Model: H1	Date: 02-Mar-01	No.: MH538001a

MB Correction

Model: H1 Date					1	No.: MH538002
Modified Article:	Fusing Unit	Prepared	by: A.	Ishiyama		
From: Technical S	ervices Dept., GTS Division					
Reason for	☐ Parts catalog correction	⊠ Vend	or ch	ange	☐ To n	neet standards
Modification:	☐ To facilitate assembly	☐ To im	prove	e reliability	()
	☐ Part standardization	☐ Othe	r ()			
Modification	From March 2001 production	n run				
Schedule:

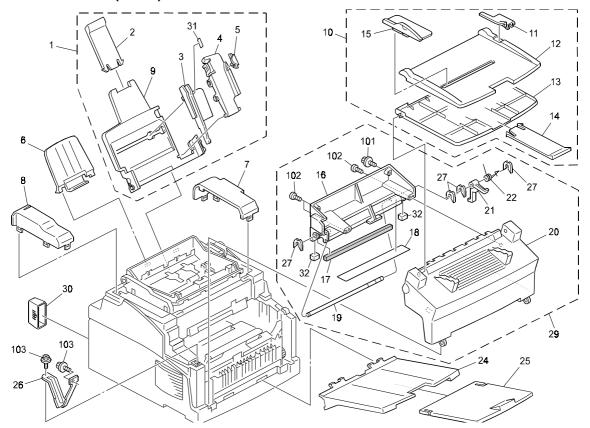
The following part numbers were printed incorrectly in the parts catalog.

Incorrect	Correct part	Description	Q'ty	Int	Page	Index	Note
part number	number	-					
G0251212		Plate Spring	1→0		3	23	Α
G0251213		Plate Spring - Left	1→0		3	28	Α
	H5384121	Spacer - Cover	0→2		3	32	Α
G0253018	H5383107	Left Bracket –Bottom Plate	1→1		11	1	
G0253202		Bottom Plate Ass'y – Paper Feed	1→0		11	34	*1
	H5384107	Insulating Sheet – Speaker	0→1		13	45	
H5381101	H5381120	ADF Base Frame	1→1		9	37	
H5381512	H5381612	Document Stopper	1→1		9	38	
H5381500	H5381600	ADF Upper Frame	1→1		9	45	
G0252489		Cover – Ground Plate	1→1		9	28	В
	H5381130	Anti-static Sheet – R1	1→1		9	54	В
	H5381131	Anti-static Sheet – R1	1→1		9	55	В
	H5384122	Spacer – Op-port	0→2		7	11	
H5383104	H5383108	Torque Limitter – Paper Feed	1→1		11	36	
G0252496		Shading Plate – ADF – Front	1→0		5	1	
G0251854		Laser Diode Unit	1→0		5	9	
	H5382046	Laser Unit	1→1		5	23	*2

^{*1:} As this is a complete assembled unit, it is not possible for SPC to supply this unit itself as spare parts. Therefore only child parts are available as spare parts.

^{*2:} The component level of the laser unit has been corrected.

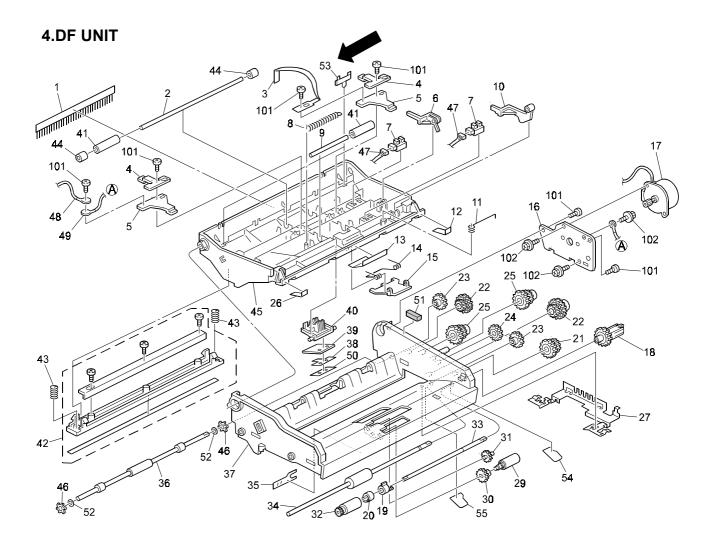
Model: H1	Dat	:e: 06-Mar-0	1	No.: MH538003	
Modified Article: A	Prepared by: A. Ishiyama				
From: Technical Se	rvices Dept., GTS Division				
Reason for	☐ Parts catalog correction	☐ Vendor ch	nange	☐ To n	neet standards
Modification:	☐ To facilitate assembly	☐ To improv	e reliability	()
	☐ Part standardization	Other ()			
Modification	From January 2001 production	on run			
Schedule:

Old part number	New part number	Description	Q'ty	Int	Page	Index	Note
	H5381571	Mylar – Document Exit	0→2	X/O	9	53

8.ELECTRICAL SECTION (H538)

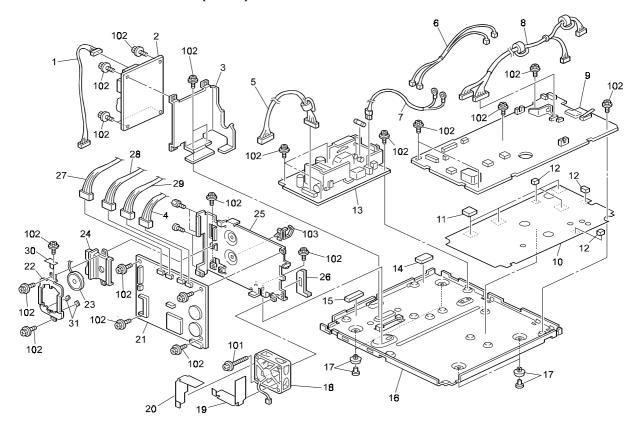
Model: H1 Dat			te: 06-Mar-0	1	No.: MH538008
Modified Article: Monitor Speaker Holder			Prepared	by: A.	Ishiyama
From: Technical Ser	rvices Dept., GTS Division				
Reason for	Parts catalog correction	☐ Vendor c	•	☐ To n	neet standards
Modification:	☐ To facilitate assembly☐ Part standardization	Other ()	ve reliability		,
Modification	From March 2001 production	run			
Schedule:

Old part	New part	Description	Q'ty	Int	Page	Index	Note
number	number				_		
H5383404	H5383408	Speaker Guide Plate	1→1		17	22	Α
H5383403	H5383410	IC Card Guide	1→1		17	24	Α
	H5383409	Holder – Speaker Guide Plate	0→1		17	30	Α
	H5383412	Spacer – Speaker Holder	0→2		17	31	Α
	04513006B	Tapping Screw – M3x6	2→3		17	102	Α
